BID ADDENDUM NO. 3

May 13, 2021
Campbell-Savona Central School District
2020 Capital Project- Phase I
2450-035

ITEM AD3-17 Refer to Drawing HS-E2.2 – FIRST FLOOR LIGHTING & FA PLAN – AREA B

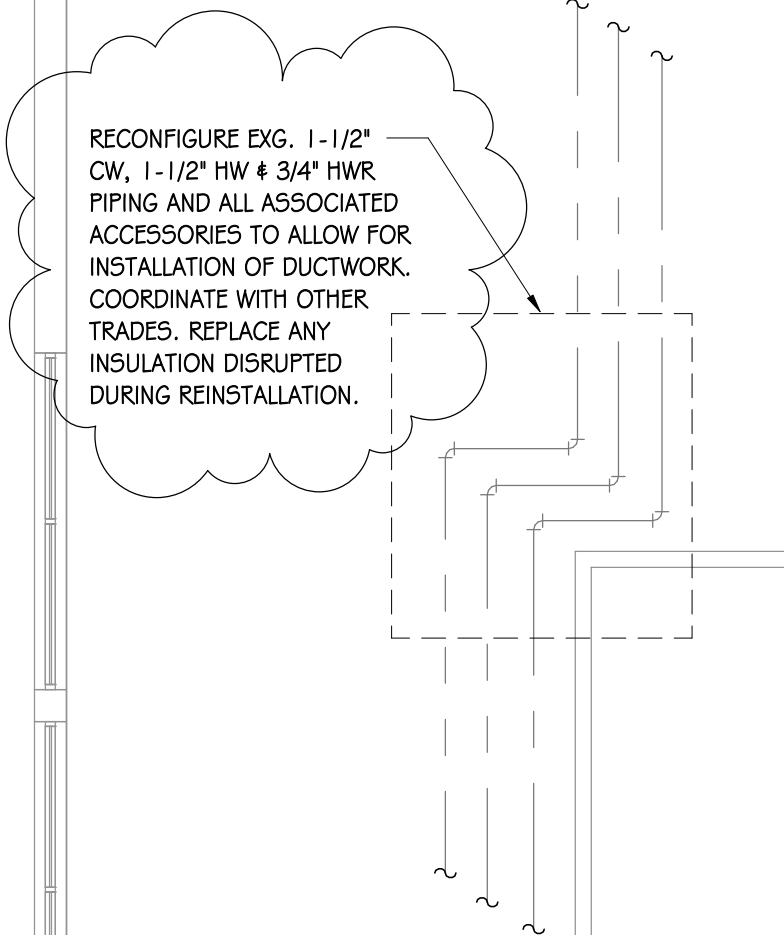
ADD Note to Generator Rm. 109A, that reads the following: “FACP is located in the upper left (North) corner of this room.”

1 REVISED POOL MECHANICAL ROOM PLAN
 1/8" = 1'-0"

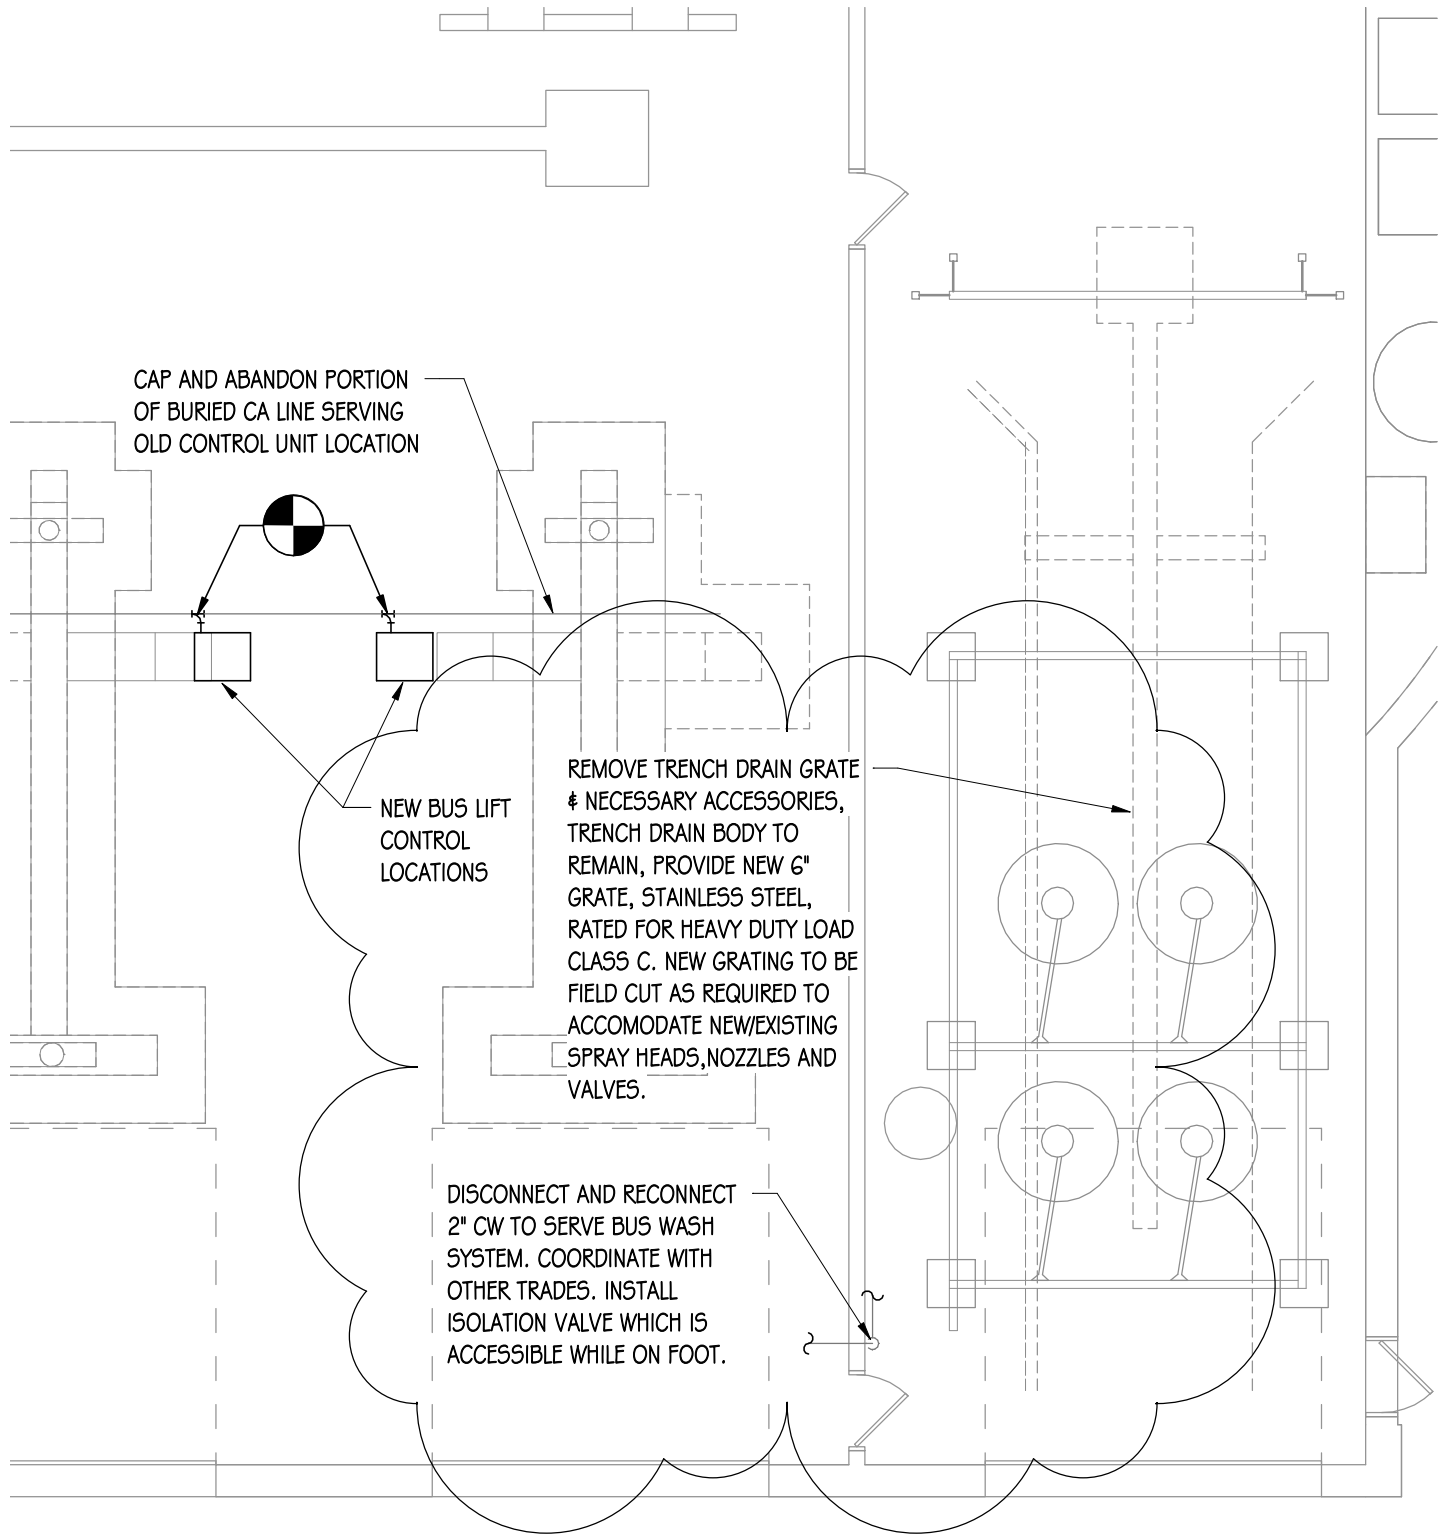
ITEM AD3-19 Refer to Drawing HS-P1.1 – SECOND FLOOR DOMESTIC PLAN – MECHANICAL ROOM

AMEND Detail 2 with AD3-P1 – REVISED POOL MECHANICAL ROOM PLAN, issued by this addendum.
